Millstone Nuclear Power Station, Unit No. 2  
Feedwater Lines

MILLSTONE NUCLEAR POWER STATION, UNIT NO. 2  
INFORMATION ON FEEDWATER LINES

## INFORMATION REQUESTED ON PWR FEEDWATER LINES

(114.00) FEEDWATER NOZZLE ASSEMBLY  
 SCALE 1 3/4" = 1'-0"

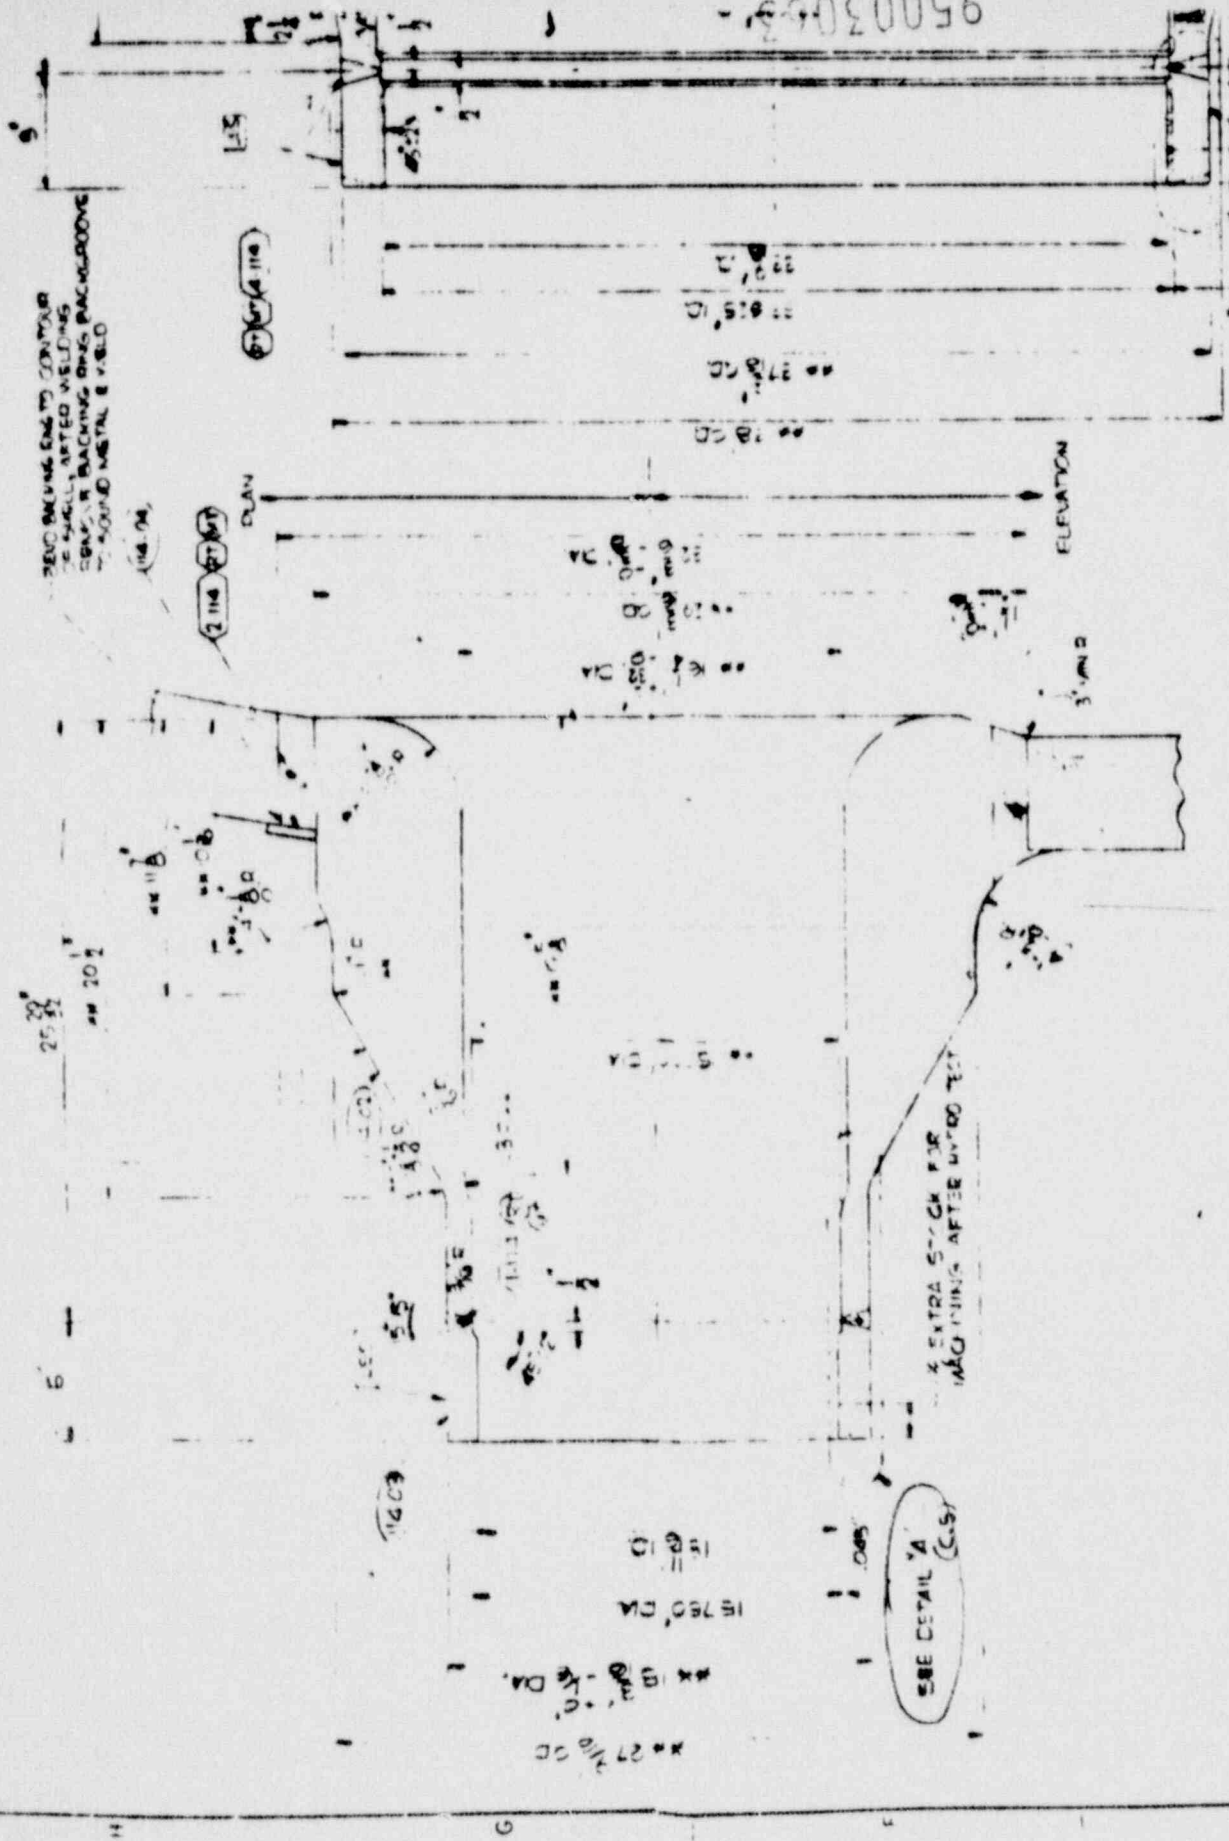
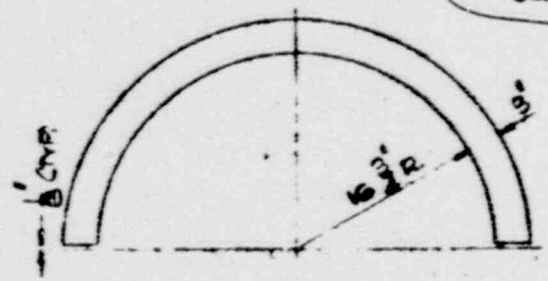
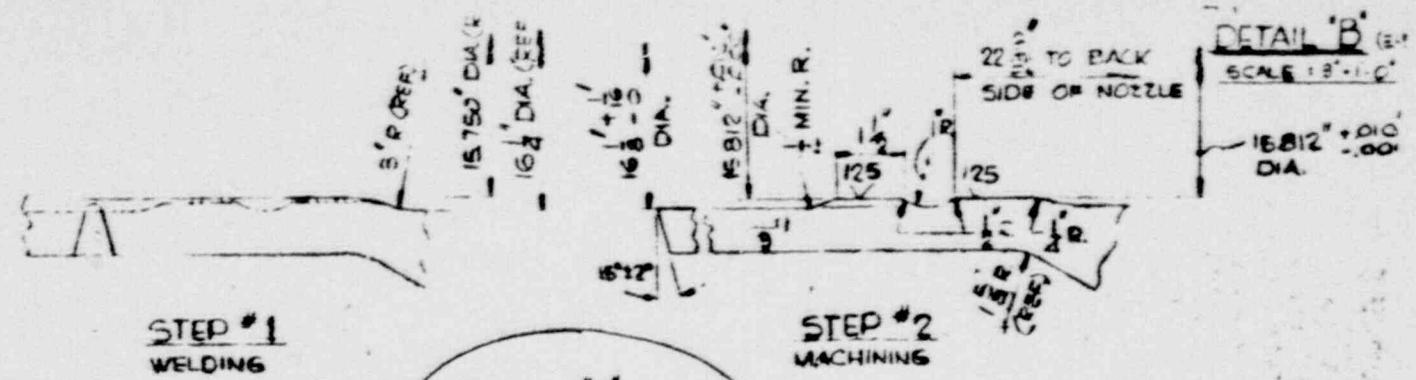
1. Provide as-built piping or isometric drawings of the feedwater line to steam generator sparger within containment. Show details of the design such as dimensions, pipe schedule, support type and locations, pipe restraints, and valve(s).

The piping isometric for the Millstone Unit No. 2 feedwater piping system inside containment is provided in enclosed drawing 2503-SKM-326. The design details for the steam generator feedwater nozzle are shown in the enclosed drawing.

FIG. 5-19  
STRESS ANALYSIS MODEL

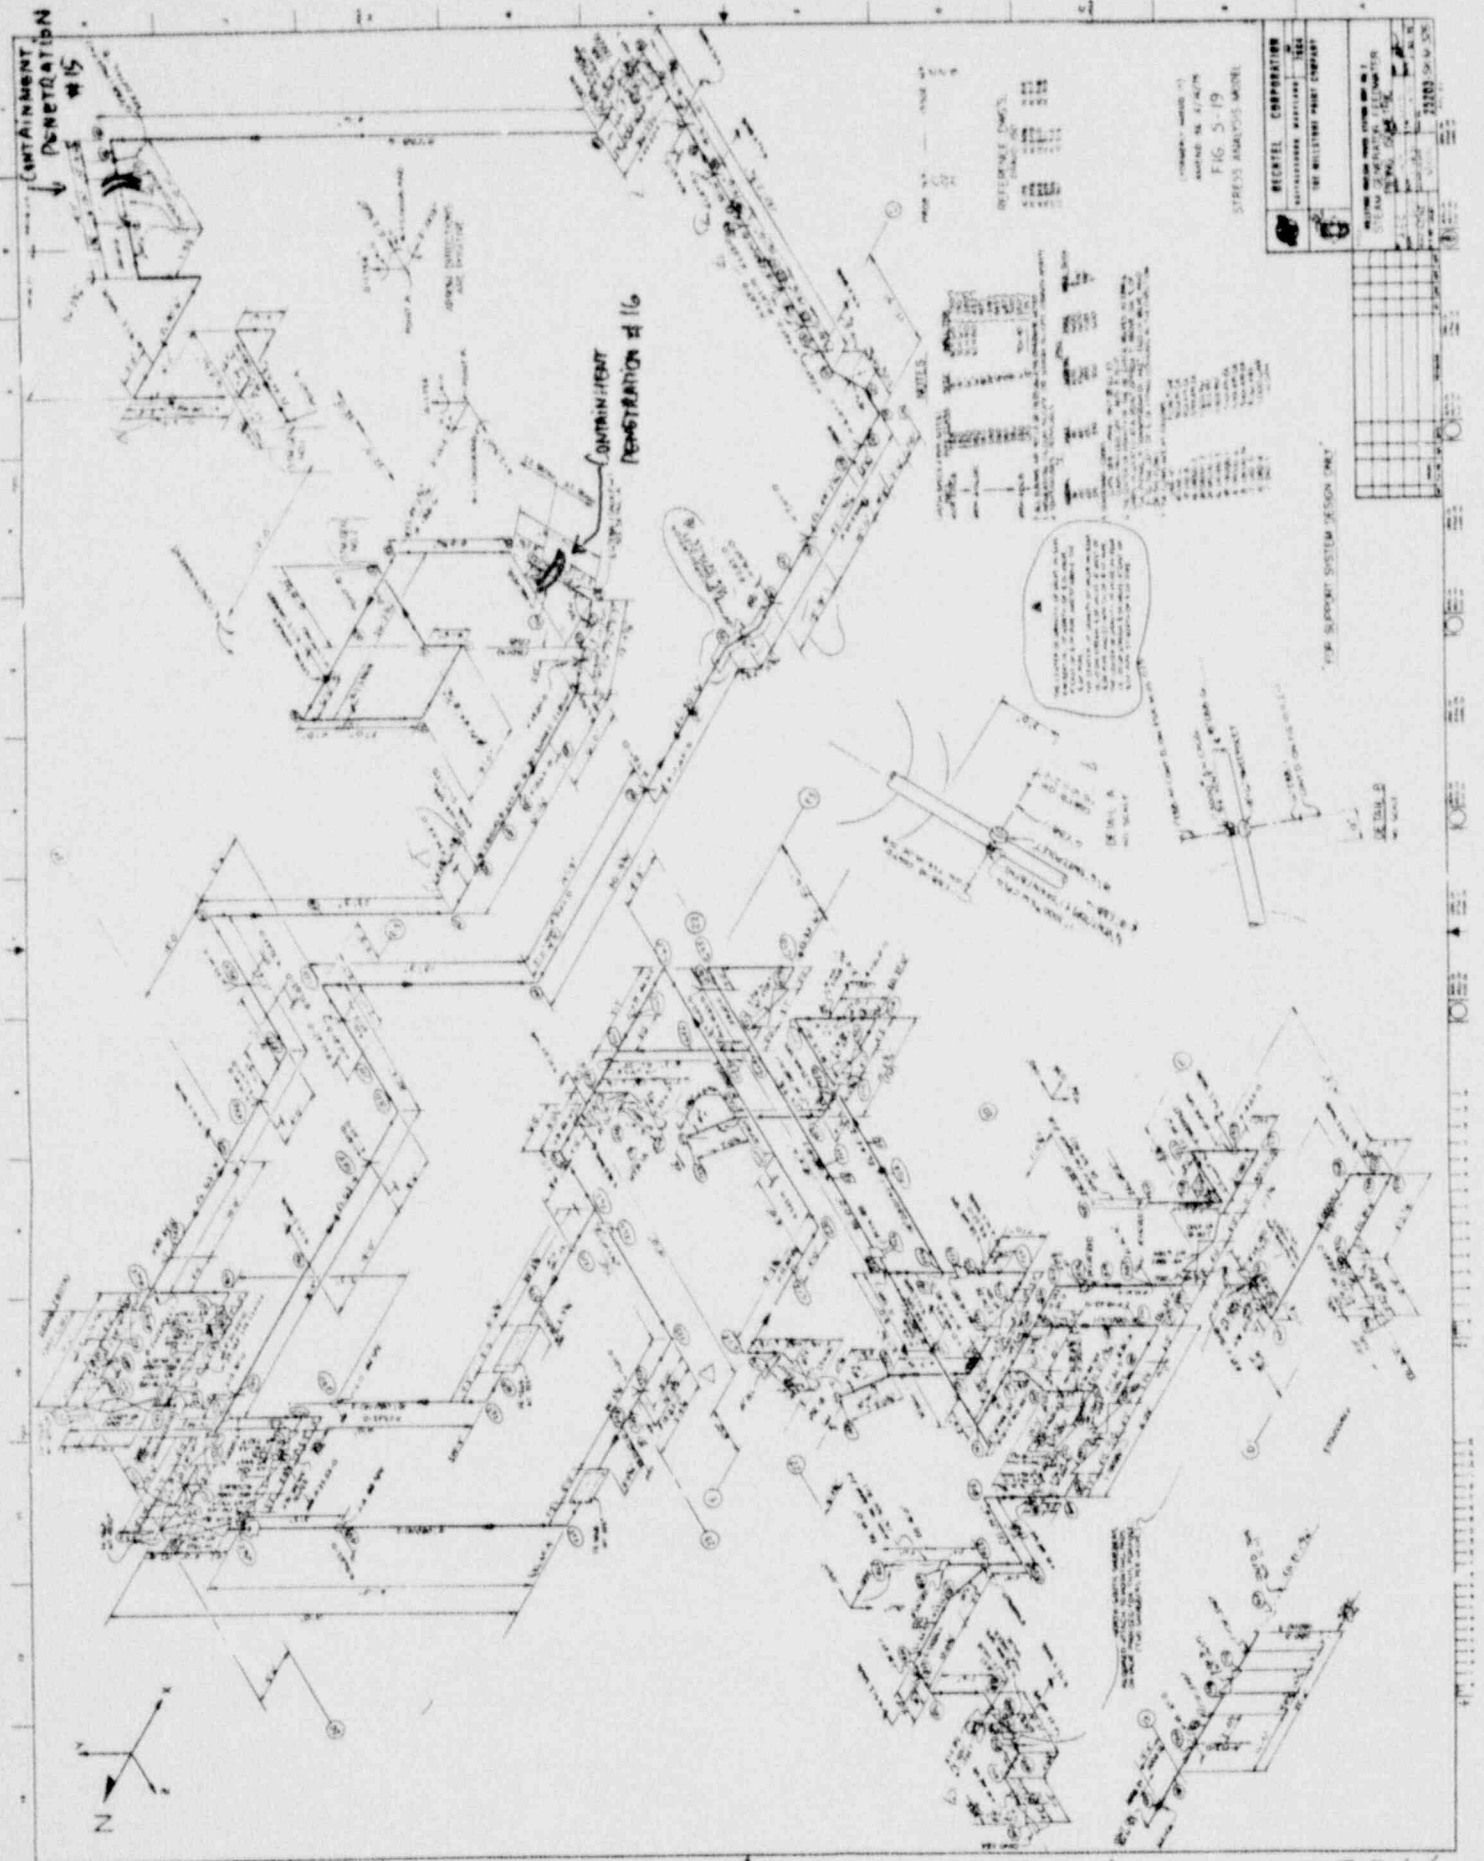
2. Provide the results of any stress or fatigue analyses which was performed for this system.

The Millstone Unit No. 2 feedwater piping inside containment was designed to ANSI B31.7, Class II-1969. No fatigue analyses are required for Class II piping systems.

A copy of the stress analysis summary for thermal expansion, operating earthquake conditions, design basis earthquake conditions for the feedwater piping system inside containment, and a summary of forces and moments at both steam generator feedwater nozzles for design basis conditions, is enclosed for information.

FIELD WELD END PREPARATION  
FUNCTION - INERT GAS SHIELDED ARC  
WELDING CONSUMABLE ELECTRODES

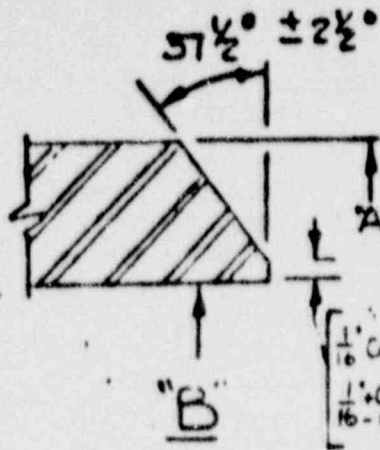
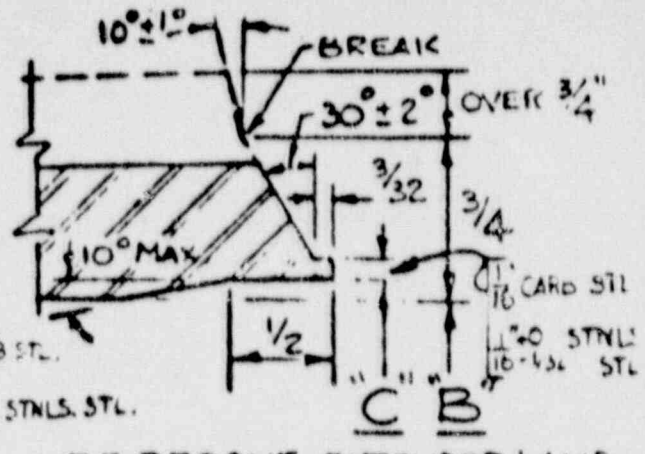
2. Provide the details of the welding process(es) used to make the nozzle-to-pipe, pipe-to-sparger, and piping welds. Include details of welding such as preheat, joint configuration (include with or without backing ring), and post weld treatment, if any.

- (a) The weld joint configuration for the feedwater piping and pipe-to-safe end welds is as shown on the enclosed drawing 7604-MS-2, Rev. 7, for pipe class EBB 18" Schedule 60 piping.
- (b) The specific welding procedure for the safe end to piping and feedwater piping welds "Welding Procedure Specification PI-AT-Lh (CVN)" is enclosed for information. The root pass of the butt welds was done by the Gas-Tungsten Arc process. The use of consummable inserts was optional. However, if used the consummable inserts were of the same material as the weld filler metal. Permanent backing rings were not used in the subject system welding.
- (c) Preheating of welds was in accordance with Paragraph 1, 2-731-2 of ANSI B31.7.
- (d) Post weld heat treatment for pressure piping welds was in accordance with Paragraph 1, 2-731 of ANSI B31.7.
